WORK ITEM 3. UPGRADE IT CLOSETS:

DEPARTMENT OF VETERAN AFFAIRS VETERANS HEALTH ADMINISTRATION			
DENTAL, STAIRWAY, IT CLOSETS PROJECT			
DATE: OCTOBER 2014	SIZE	FSOM NO.	REV
SCALE: NO SCALE		SHEET 2 OF 3

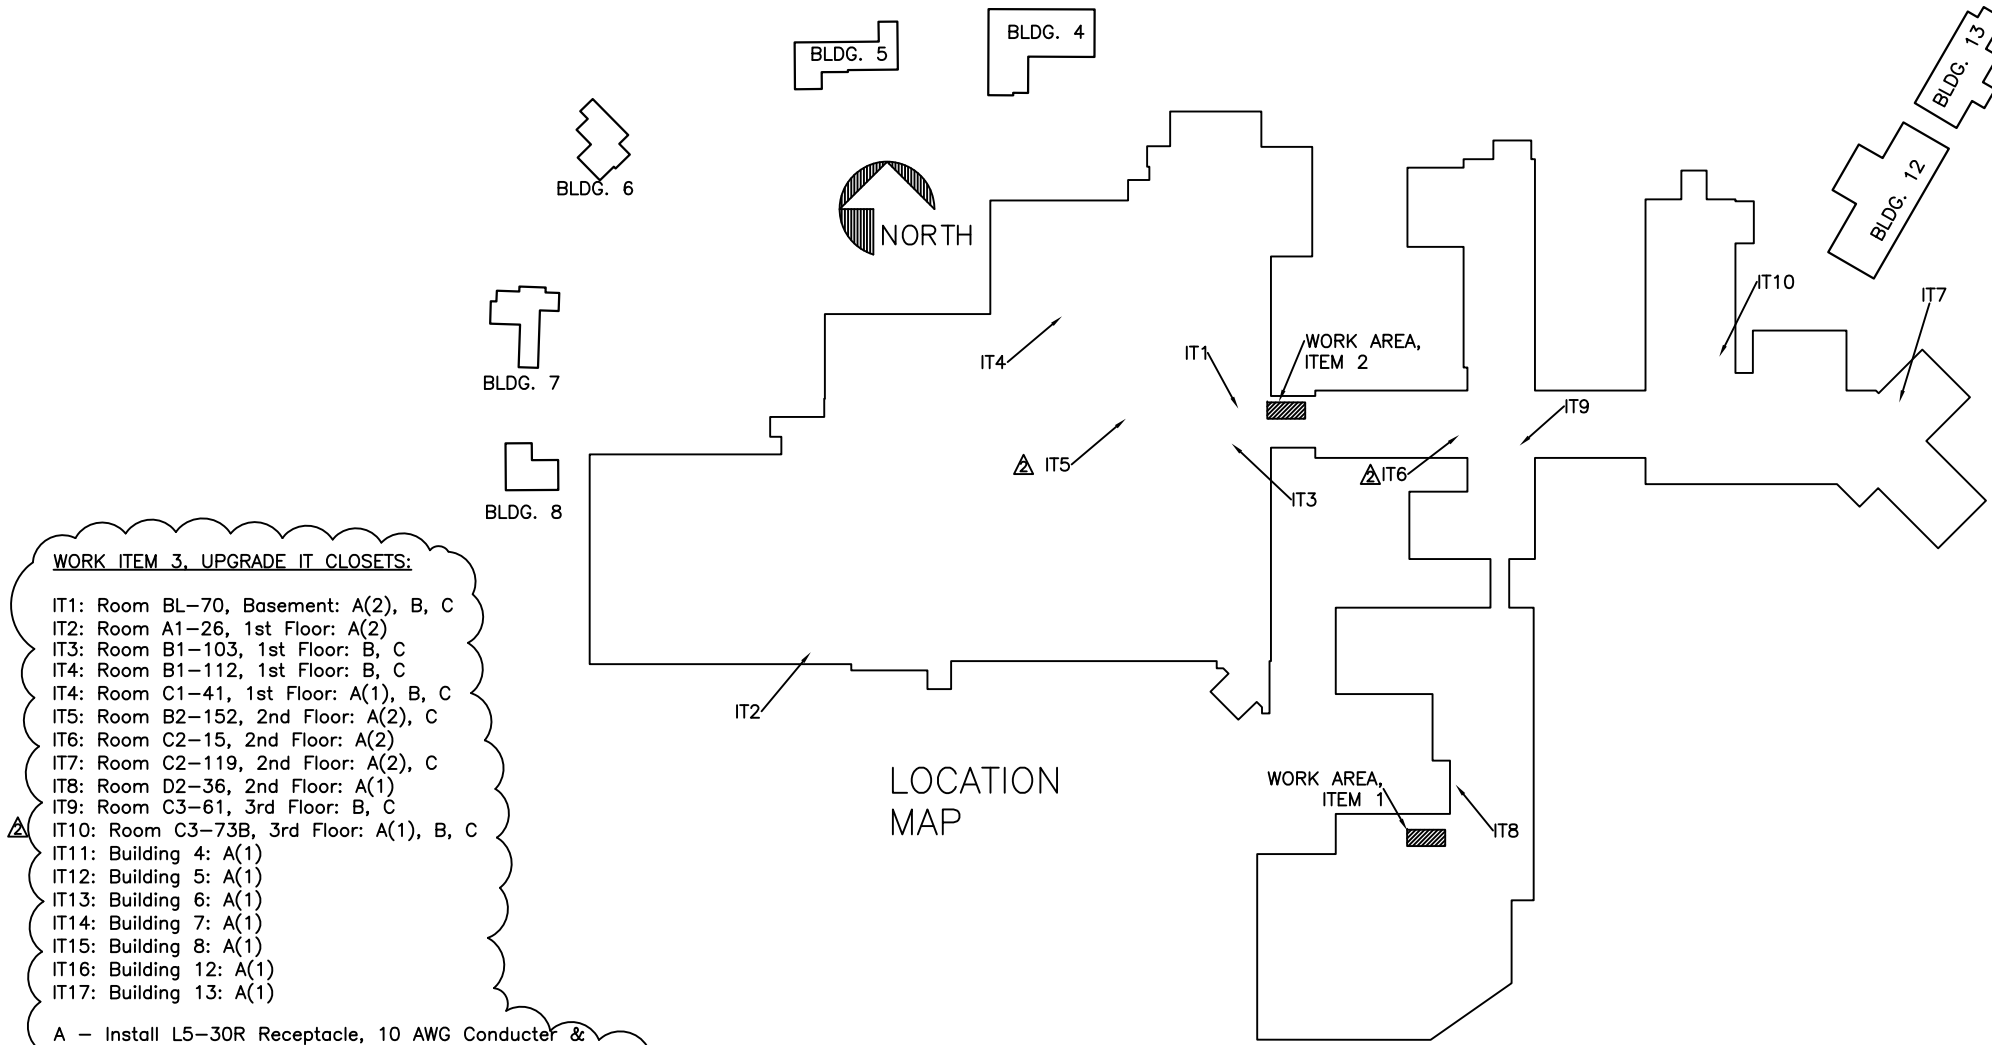
REVISIONS				
ZONE	REV	DESCRIPTION	DATE	APPROVED
	⚠	Revised work in IT Closets to show number of receptacles required. Added IT18: Room B2-152.	11/05/14	SR
	⚠	Room B2-93 number changed to B2-152. Removed IT18 from revision 1. Corrected designation for room C2-15 to IT6.	11/13/14	SR

IT1: Room BL-70, Basement: A(2), B, C
IT2: Room A1-26, 1st Floor: A(2)
IT3: Room B1-103, 1st Floor: B, C
IT4: Room B1-112, 1st Floor: B, C
IT4: Room C1-41, 1st Floor: A(1), B, C
IT5: Room B2-152, 2nd Floor: A(2), C
IT6: Room C2-15, 2nd Floor: A(2)
IT7: Room C2-119, 2nd Floor: A(2), C
IT8: Room D2-36, 2nd Floor: A(1)
IT9: Room C3-61, 3rd Floor: B, C
IT10: Room C3-73B, 3rd Floor: A(1), B, C
IT11: Building 4: A(1)
IT12: Building 5: A(1)
IT13: Building 6: A(1)
IT14: Building 7: A(1)
IT15: Building 8: A(1)
IT16: Building 12: A(1)
IT17: Building 13: A(1)

A - Install L5-30R Receptacle, 10 AWG Conductor & Conduit from Electrical Room to IT Closet and New 30 Amp Breaker in Electrical Panel. Number in parenthesis represents number of receptacles required for that room.
B - HVAC
C - Provide and install 24" x 5" security louver in existing door.
